## The Hirwaun Generating Station Order

# APPLICATION TO MAKE A NON MATERIAL CHANGE TO THE HIRWAUN GENERATING STATION ORDER

<b>PINS Reference Number:</b>	EN010059
<b>Document Reference:</b>	NMC
<b>Regulation Number:</b>	Regulation 4
<b>Author:</b>	Hirwaun Power Limited

Title:  
**OVERALL PLAN  
Reg5(2)(o)**

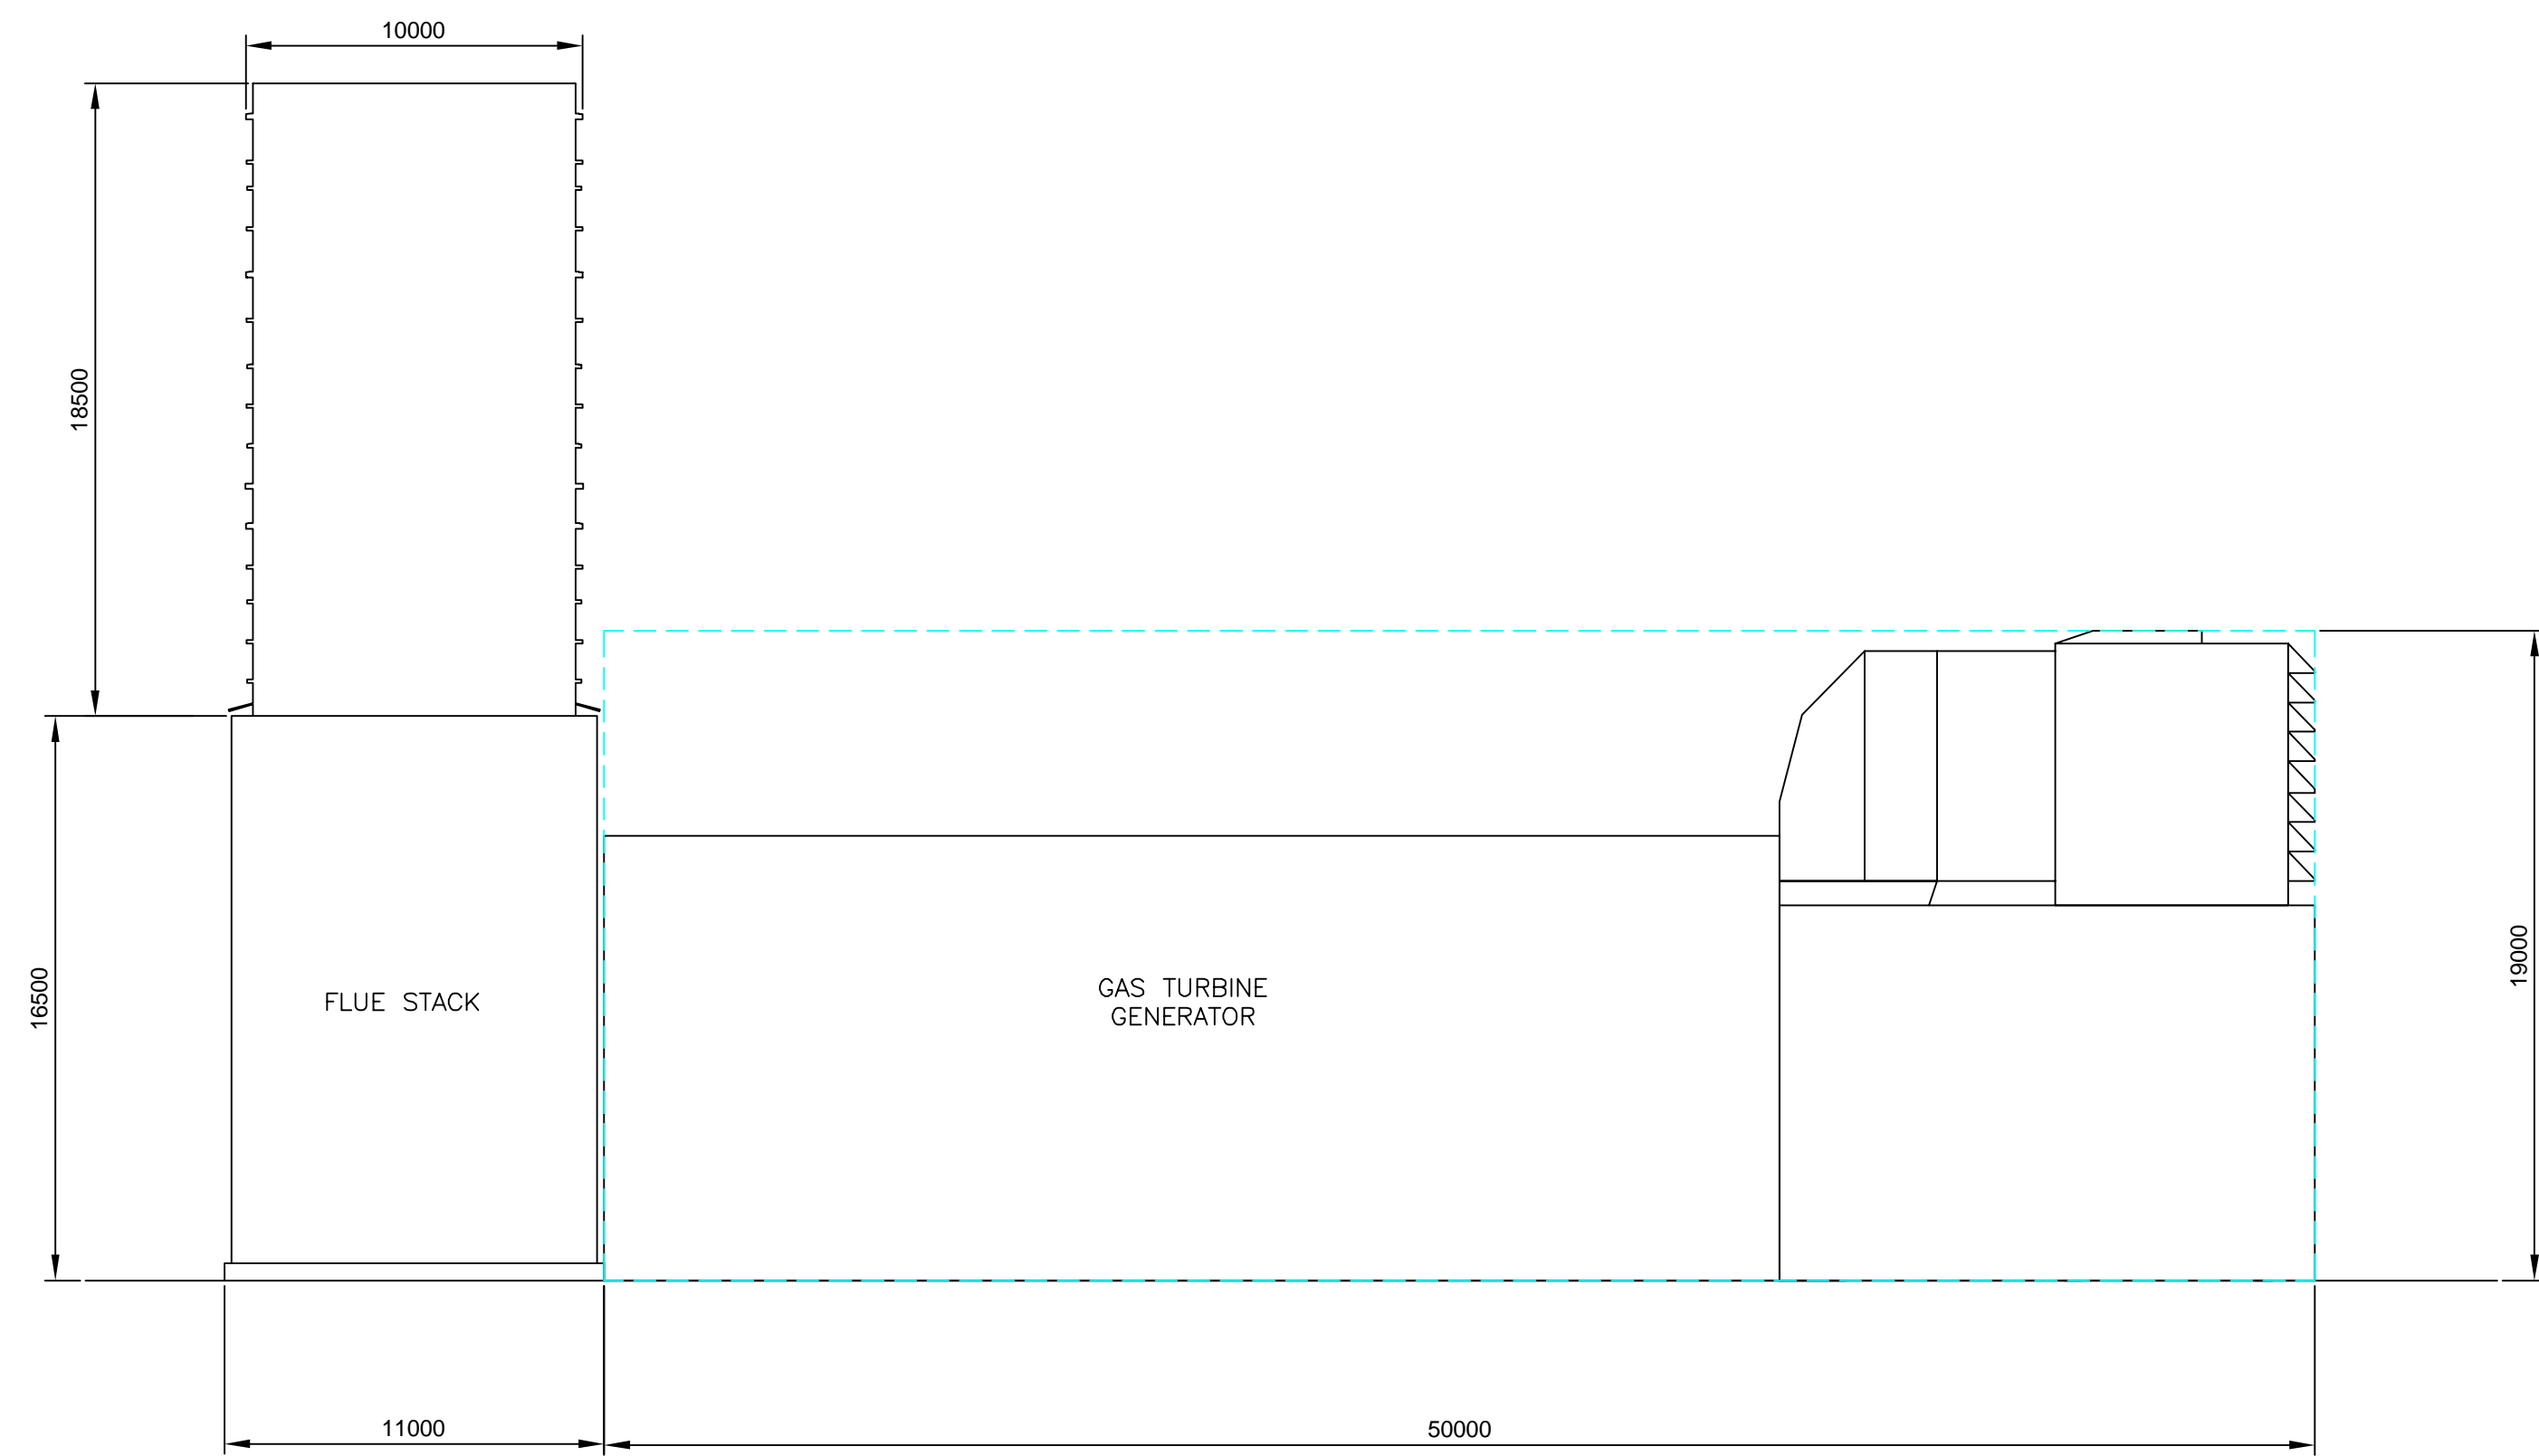
#### 4.7 Change Six: Switchyard/banking compound (numbered word 2C)

- 4.7.1 The numbered work areas shown on the Works Plans, and environmental assessment undertaken as part of the application for the authorised development, were based on a realistic worst case solution to accommodate up to five GTGs.

- 4.7.2 Should HPL opt for the single GTG scenario, this considerably reduces the overall size of the footprint of the Power Generation Plant. In the event that this option is constructed, economically and practically it is not logical to site the switchyard so far away from the GTG.

- 4.7.4 The benefit of this change is that it would result in a tighter footprint for the generating station.
- 4.7.5 This change is non-material because:

- (a) The footprint of the switchyard and banking compound is unchanged. The changes are to the layout of the Power Generation Plant Site (plant buildings/ancillary structures), rather than the Order Limits.

- (b) Figure 1, 2, 4, 5 and 6 of the Environmental Report show the proposed single GTG scenario and the proposed changes.
- (c) The screening exercise set out in Chapter 4 of the Environmental Report identifies the potential for a change in the environmental effects predicted in the Environmental Statement. No change in impacts is predicted as a result of these changes for each of the environmental topics considered.
